CONSTRUCTION PLANS

ADVENTHEALTH PARKER EXPANSION

DRAWING TITLE: **COVER SHEET**

VICINITY MAP
NO SCALE

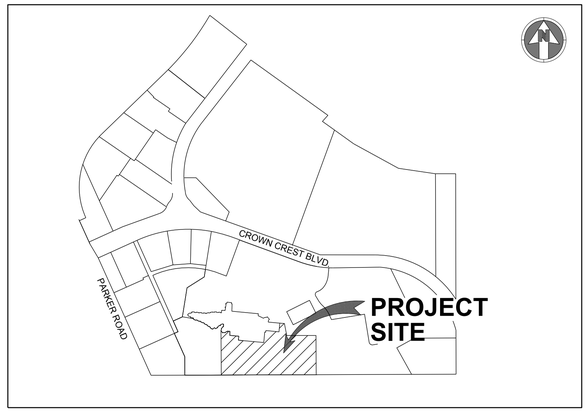
Vicinity Map shall be at a scale of 1"=2,000' and include location and names of all aerial roadways within one mile of proposed construction. Include any major drainageways in this area.

DRAWING NUMBER:
C022

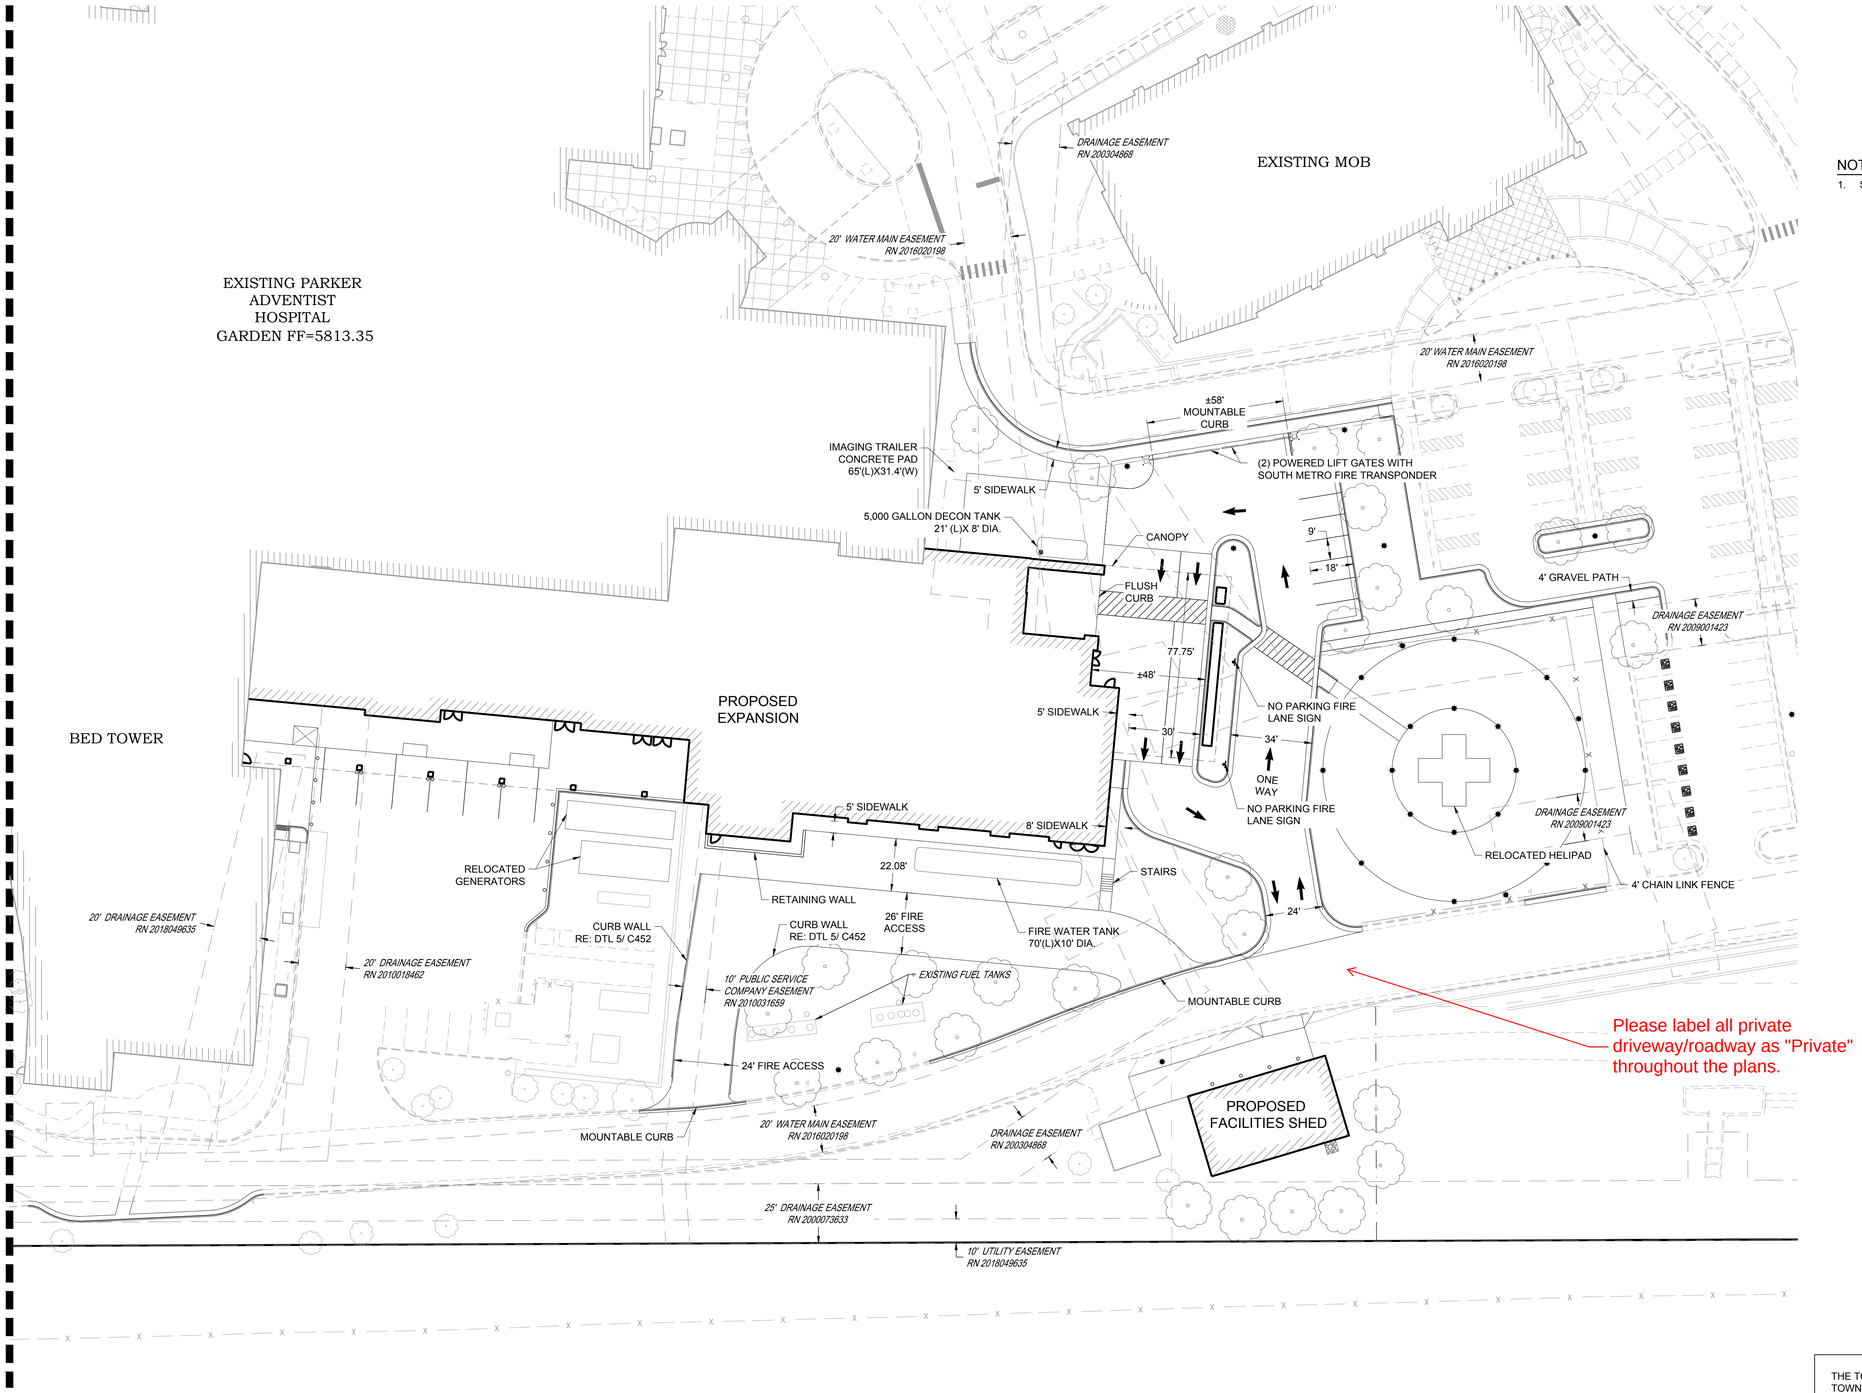
Please include Key Map

DRAWING NUMBER: **C023**

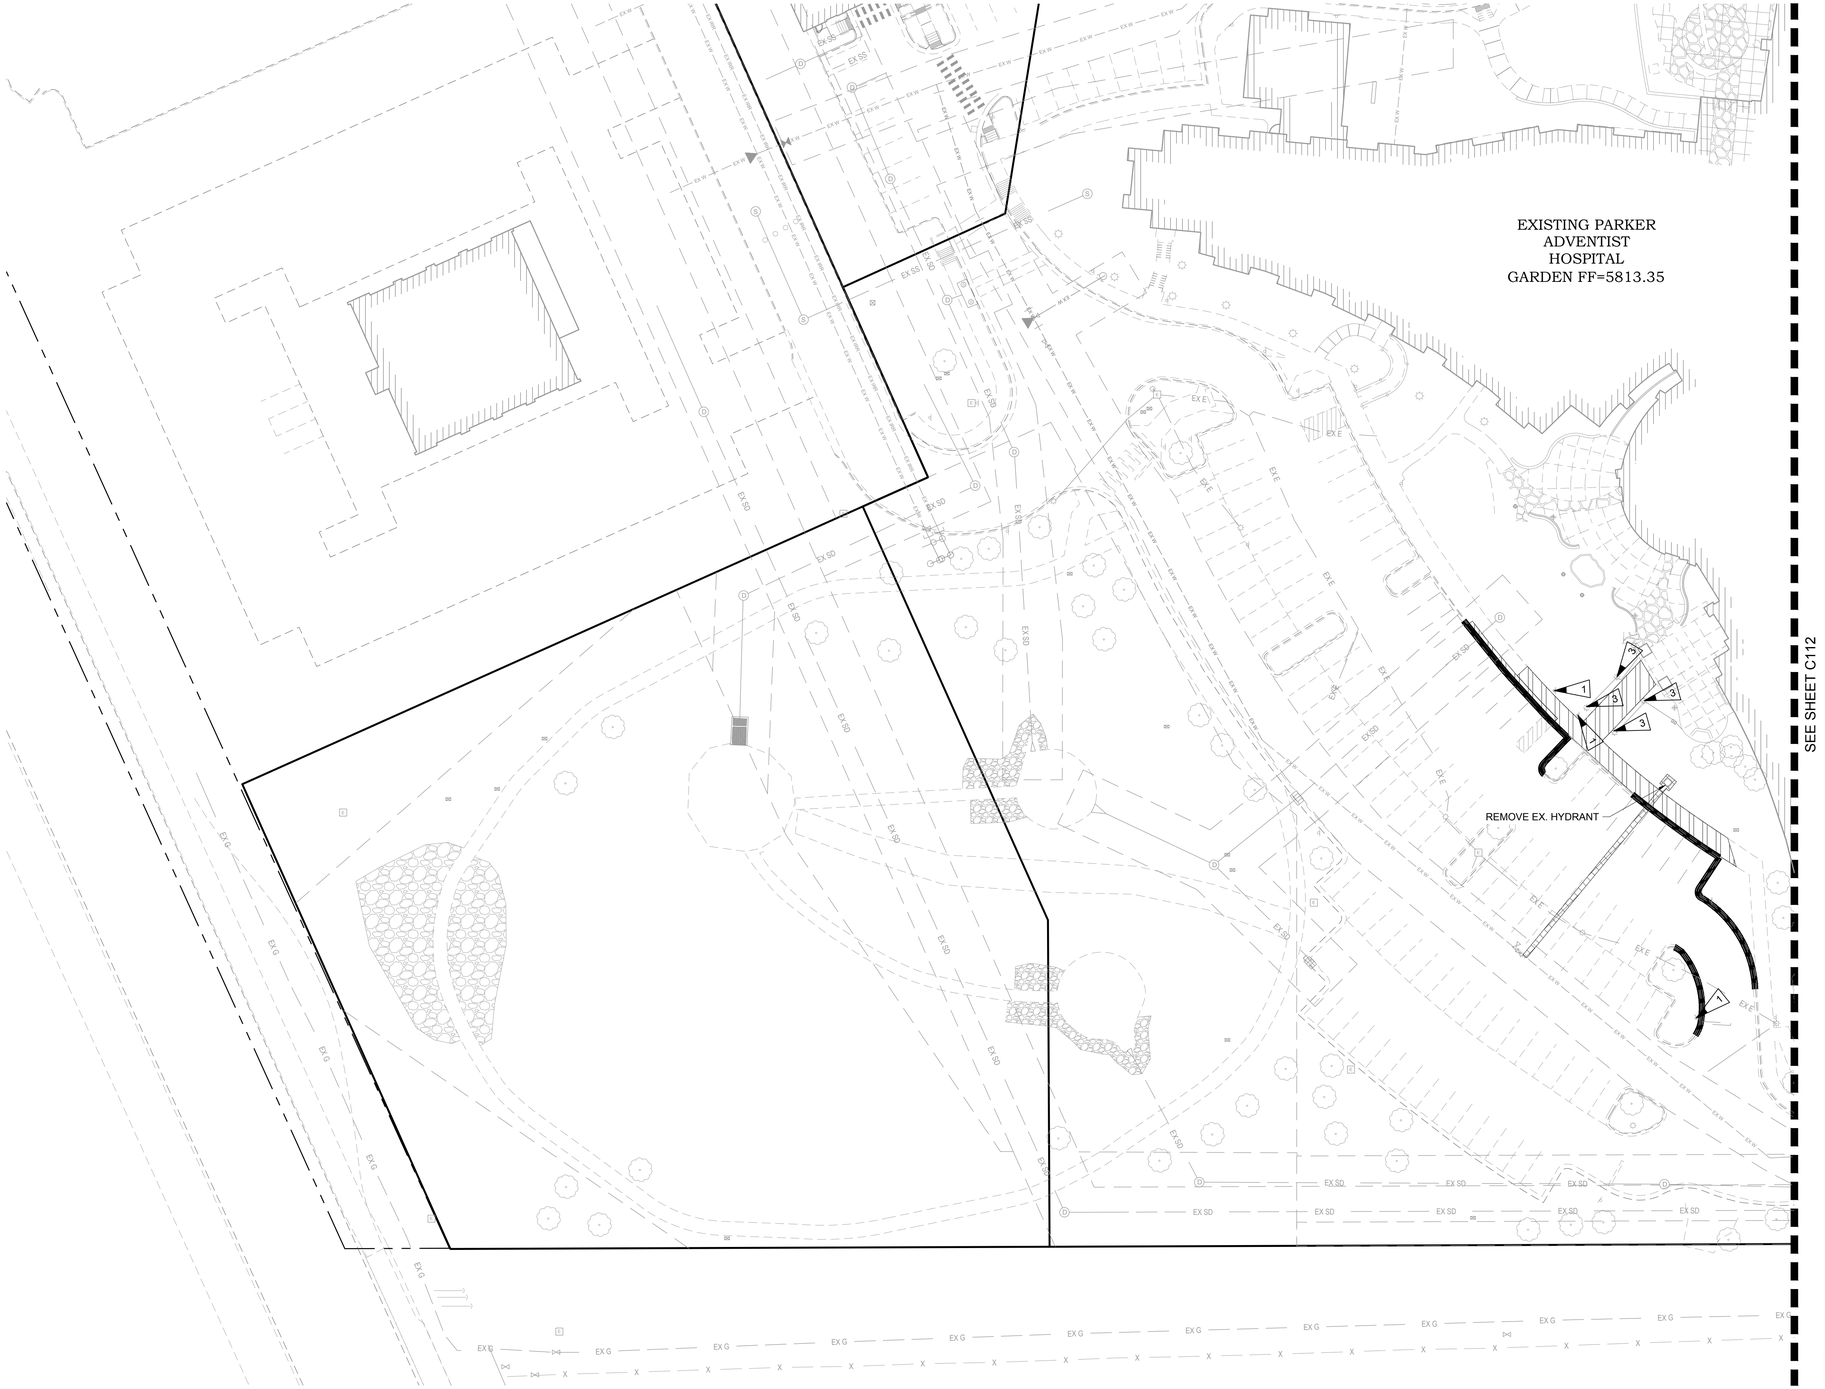
Please include Key Map

C111

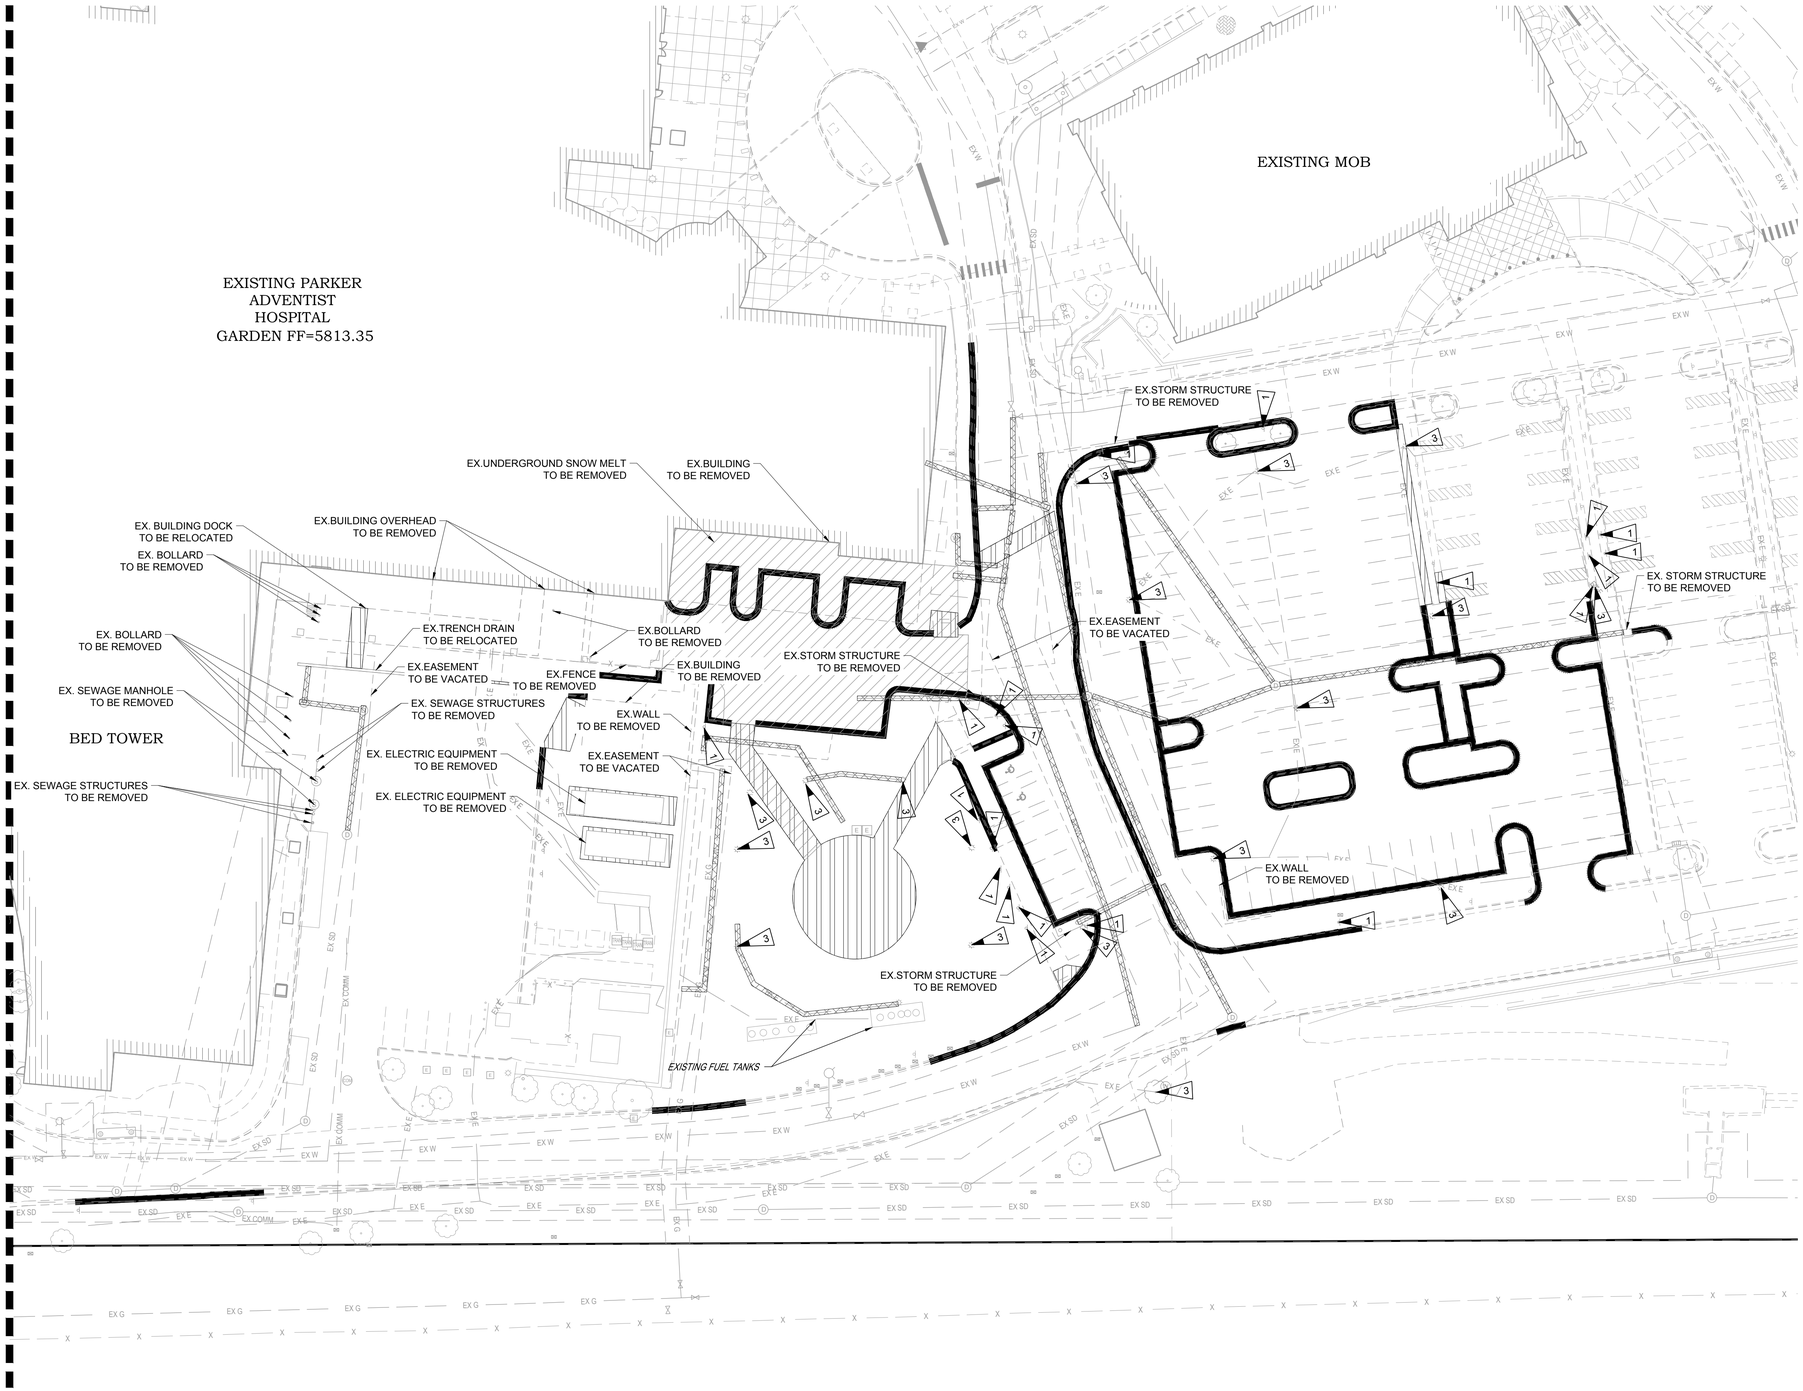
Please include Key Map

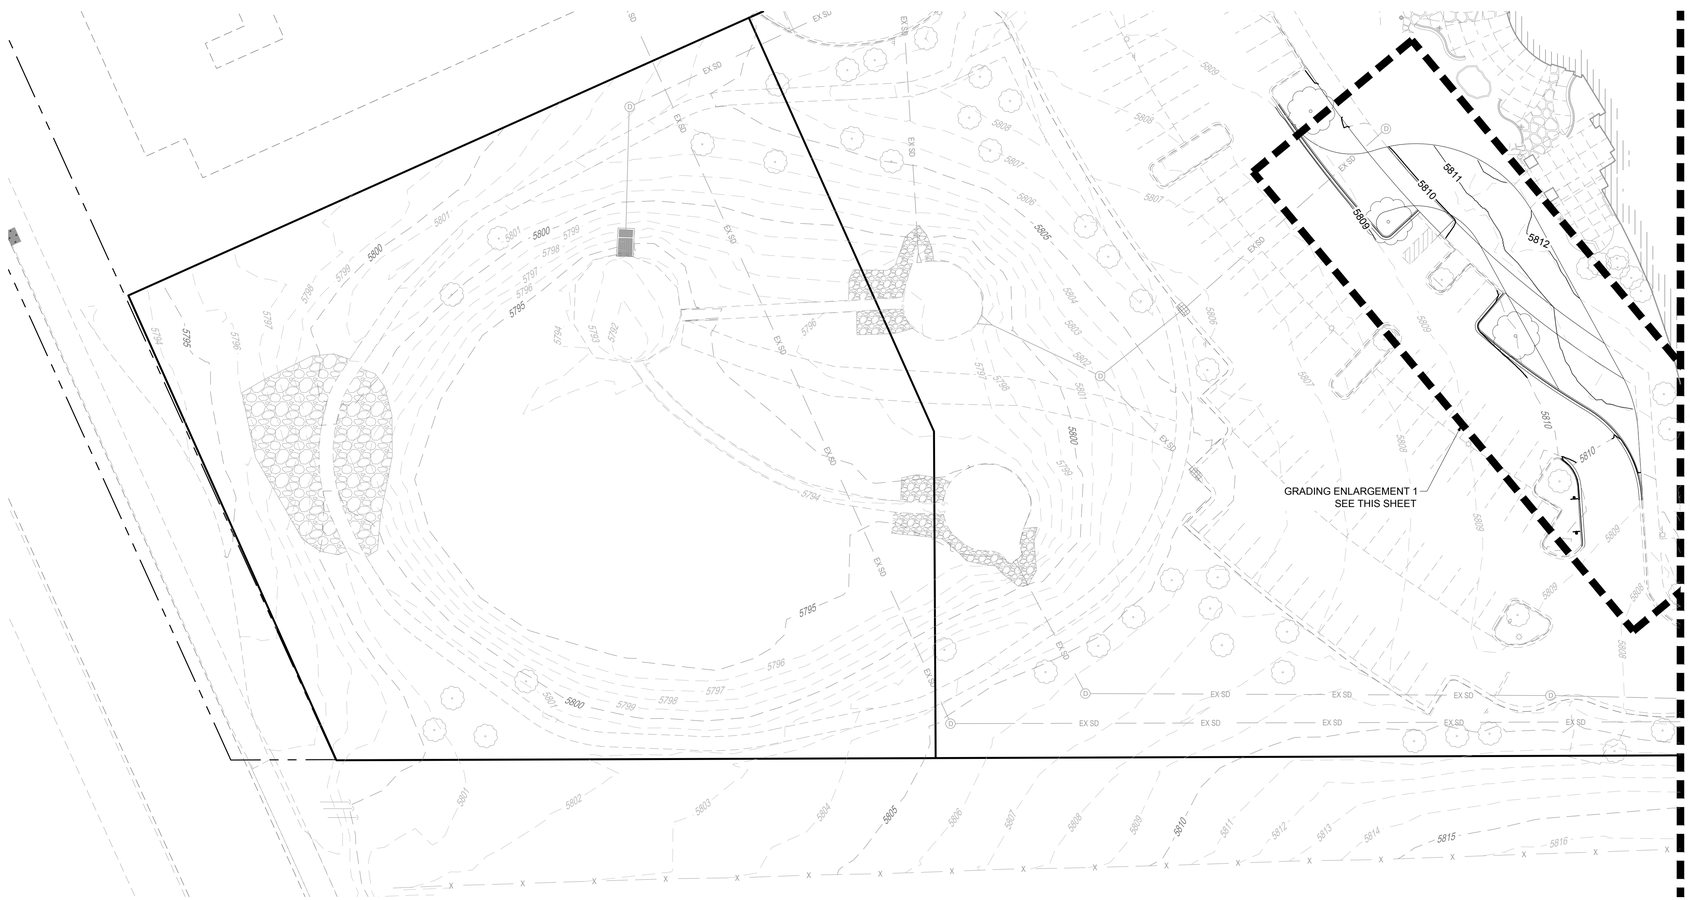
Please include Key Map
